SUBJECT: RECENCY EXTENSION DETERMINATION ON PROPOSED SUBSURFACE DREDGED MATERIAL PREVIOUSLY CHARACTERIZED AS SUITABLE UNDER THE EAST WATERWAY TERMINAL 18 PROJECT AND THE STAGE II CHARACTERIZATION PROJECT, EVALUATED UNDER SECTION 404 OF THE CLEAN WATER ACT (CWA) FOR OPEN-WATER DISPOSAL AT THE ELLIOTT BAY DISPOSAL SITE.

To: Dave Kendall, USACE
From: Doug Hotchkiss, Port of Seattle, Susan McGroddy, Windward
Subject: East Waterway non-time critical removal action: Phase 1 Removal area
Date: November 7, 2003

Map 1. East Waterway subsurface (>4ft) DMMUs that met PSDDA criteria for open-water disposal

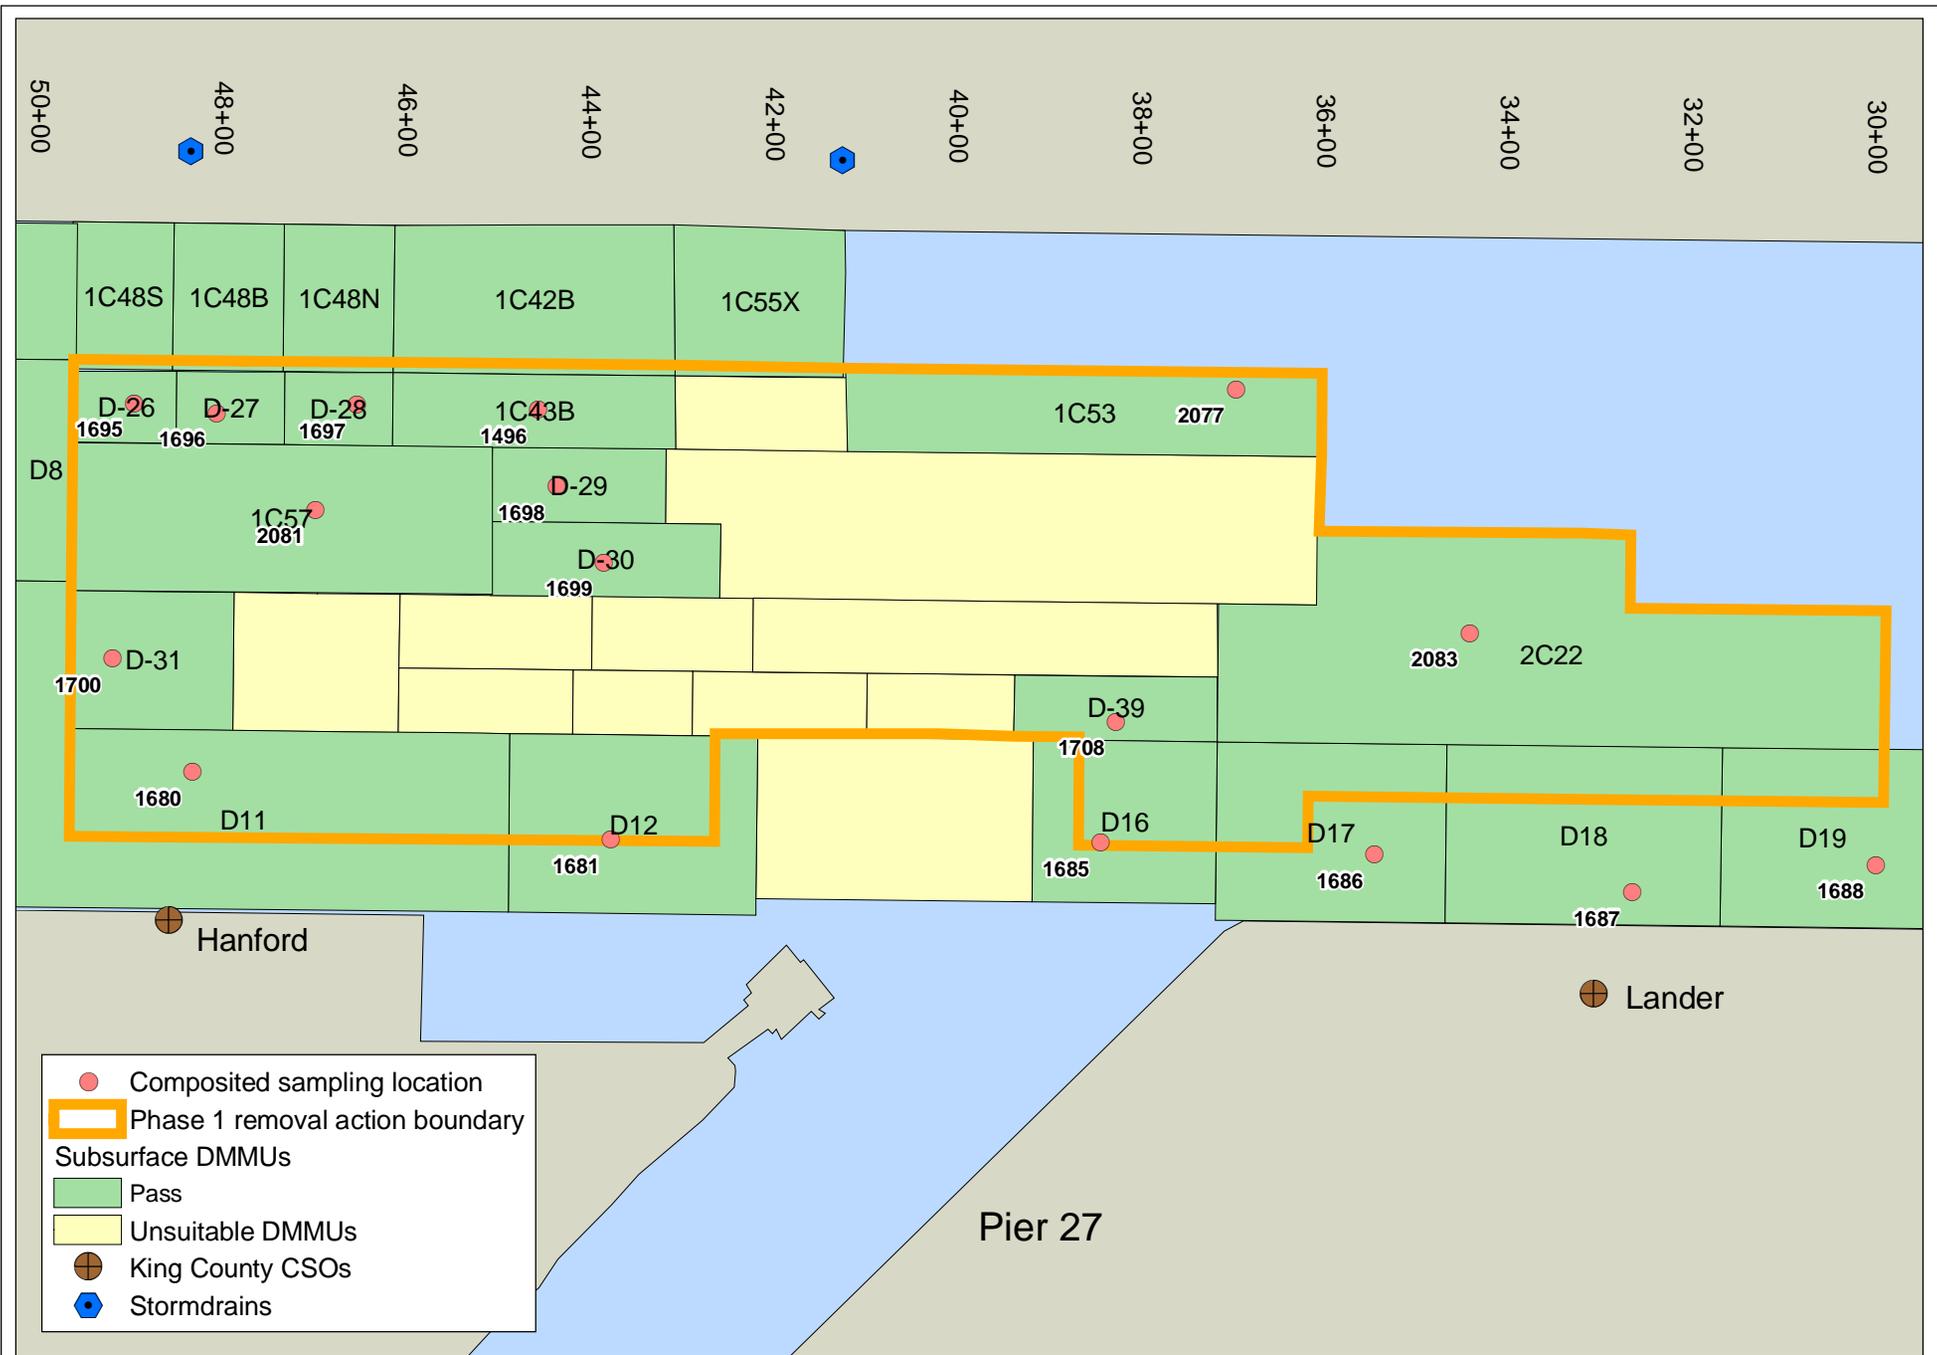
Terminal 18 (T-18) sediment characterizations following the DMMP process were conducted in two main stages. The first-stage area (Stage 1) was characterized in 1996 and the second-stage area (Stage 2) was characterized in 1998. In addition, sediments within this area were characterized as part of the the East Waterway Deepening project in 1998. Map 1 identifies the suitable subsurface DMMUs within the Phase 1 Removal area.

DMMUs within the Phase 1 Removal area were characterized as part of the T-18 sediment characterization (EVS 1998) and the East Waterway channel deepening sediment characterization (SAIC 1999). The results of these characterizations are summarized in Table 1. The chemicals that were present at concentrations above the screening level (SL) as well as the results of bioassay testing conducted with these samples.
